## **Response to Submissions**

State Significant Development  
Application SSD-81300458

Residential Flat Buildings  
85-91 Thomas Street, Parramatta

Submitted to Department of Planning,  
Housing & Infrastructure

Figure 1: Extract of lower ground and ground floor plan with skylight to internal CoS shown with yellow arrow (Source: PTI/PPUD)

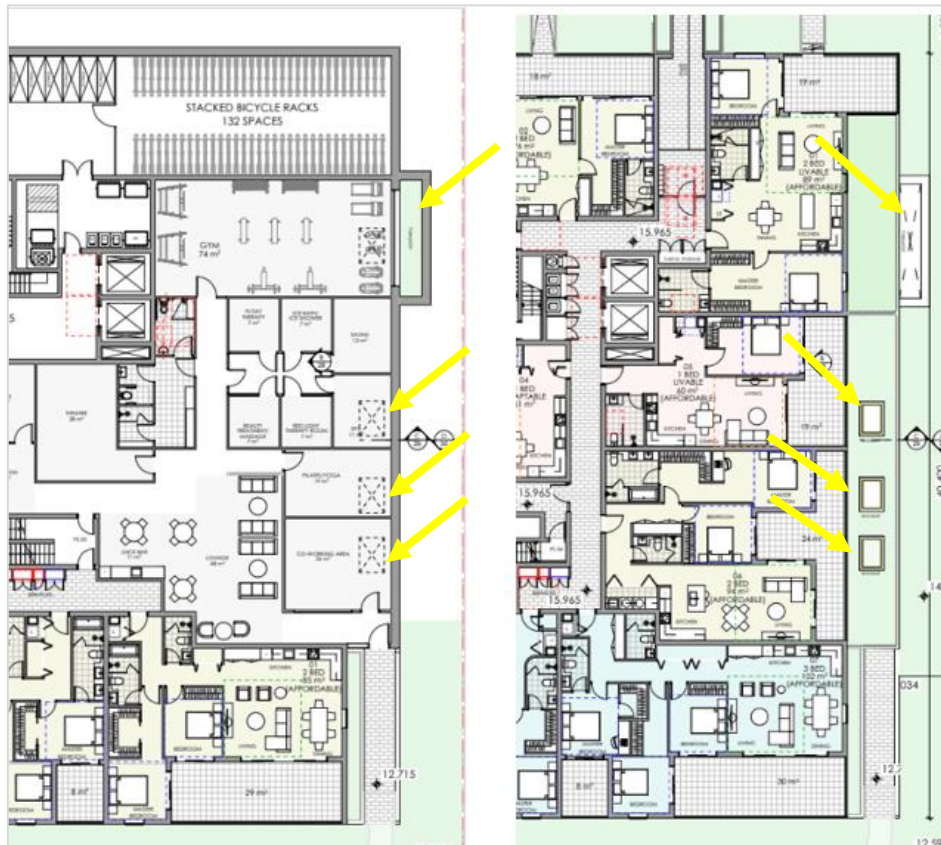
*Issue:* DPHI queried whether the amenity of the proposal’s internal open space was suitable as there was an assumption that such space was not provided with natural light.

*Response:* Whilst the internal CoS is within the lower ground, over head sky lights were included to enable natural light entry, as shown in the following extract of the architectural plans.

Figure 2: Extract of basement/lower ground floor plan with new location of waste storage facilities outlined yellow (Source: PTI/PPUD)

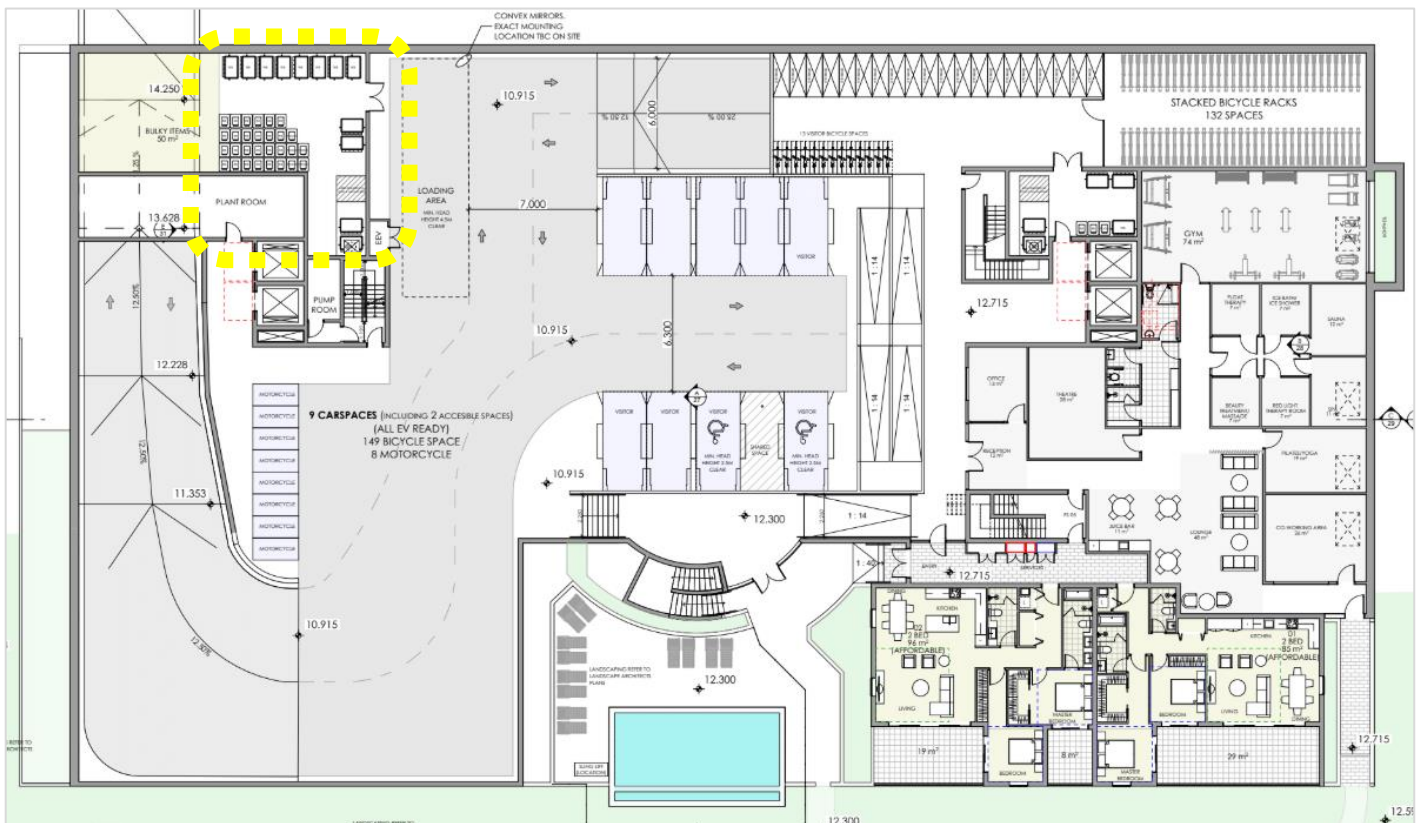
*Issue:* Submissions from the public and DPHI raised concern with the visual impact associated with waste bins which the application as submitted proposed to store at ground level, between the proposed envelope and the western side boundary. Similarly, submissions raised concerns with safety issues arising from waste collection vehicles emptying waste bins from within the Thomas Street road reserve. Such submissions were provided by individuals, the City of Parramatta Council as well as DPHI.

*Response:* The EIS confirmed, with input from the project architect as well as traffic engineers Genesis Traffic, that the originally proposed location and collection of waste was suitable. Nevertheless, the proponent has agreed to relocate all waste storage facilities to within the basement. Subsequently, waste collection will occur entirely onsite, specifically, within the proposed basement.

In order to accommodate the relevant waste vehicle within the proposed basement, the basement ramp head height is increased from 3.5m to between 4m and 4.5m. The increase in head height clearance was achieved largely by deleting 1 dwelling and relocate some other floor space. This also ensures that the originally proposed maximum height of 30m, as part of the concurrent rezoning, does not change.

The application as originally submitted included waste storage facilities in the north western corner of the site's ground floor. Subsequently, kerb side waste collection was proposed.

All waste storage is now proposed within the basement. Waste collection would, therefore, take place entirely within the proposal's basement. These revisions have been reviewed and endorsed by the project traffic engineer, Genesis Traffic.
